MEMORANDUM

Subject: **QRCC – Red-line Change**

QUAIL RIDGE COUNTRY CLUB GOLF COURSE SITE PLAN
ACTON, MASS.

VALET PARKING SKETCH PLAN

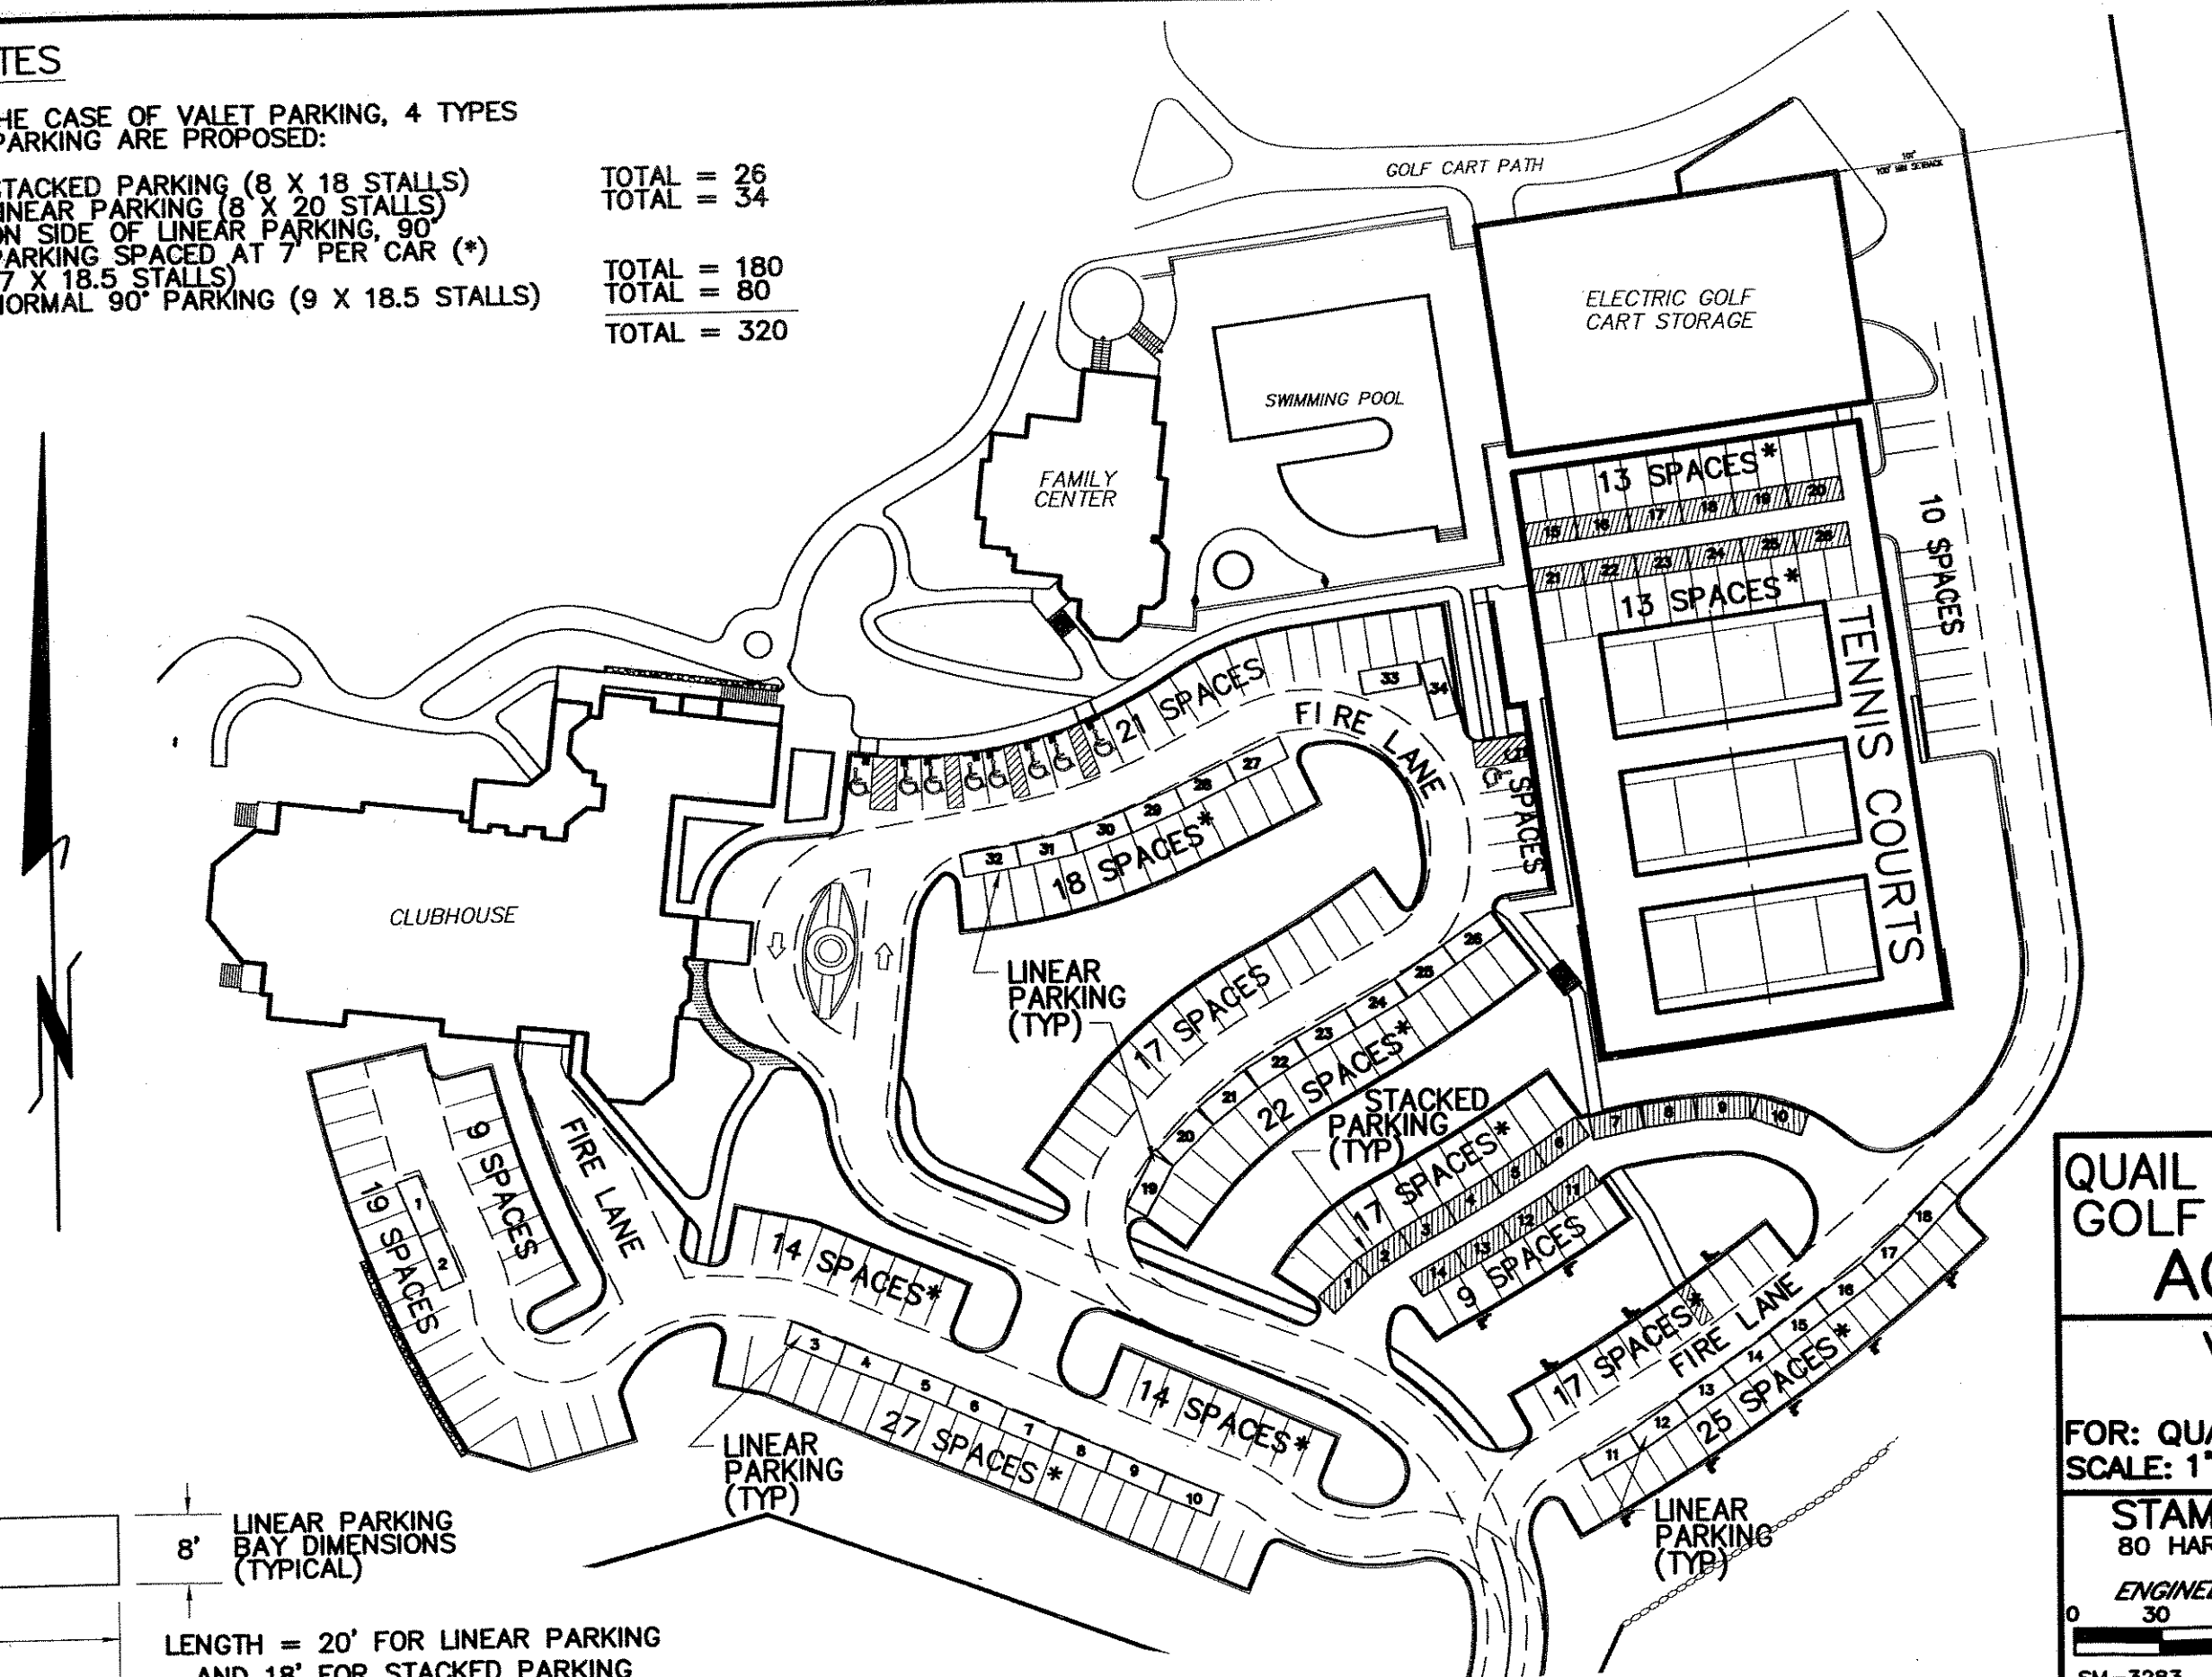
Quail Ridge Country Club has asked for a red-line change of the approved plan to modify the maintenance building and surrounding parking. The proposed change from a two-story to a single-story building lowers cost, but requires the relocation of 10 parking spaces. In addition, the revisions show the relocation of 26 valet parking spaces from the lower tennis court to the upper tennis court. See attached plan sheets:

In order to enhance the aesthetics of the site, the Golf Cart Storage Building has been redesigned to provide for a lower profile. The previous design was a 2-story, 11,722+/- square foot building. The new design is a single-story, 10,000 +/- square foot building. In addition the ten parking spaces abutting the building have been relocated next to the tennis courts.

1. Recharge roof run-off from the maintenance building directly into the ground. (The change to a single story building reduces building square-footage, but increases the building footprint, and with it the impervious coverage and potential run-off. Recharging roof runoff ensures that the site's drainage system does not get overcharged.)
2. Add perimeter landscaping designation at the sides of the relocated parking lots to comply with ZBL section 6.7.6. Landscaping materials should be equivalent to those on the originally approved plan.
3. Submit revised red-line plan for Planning Department records.
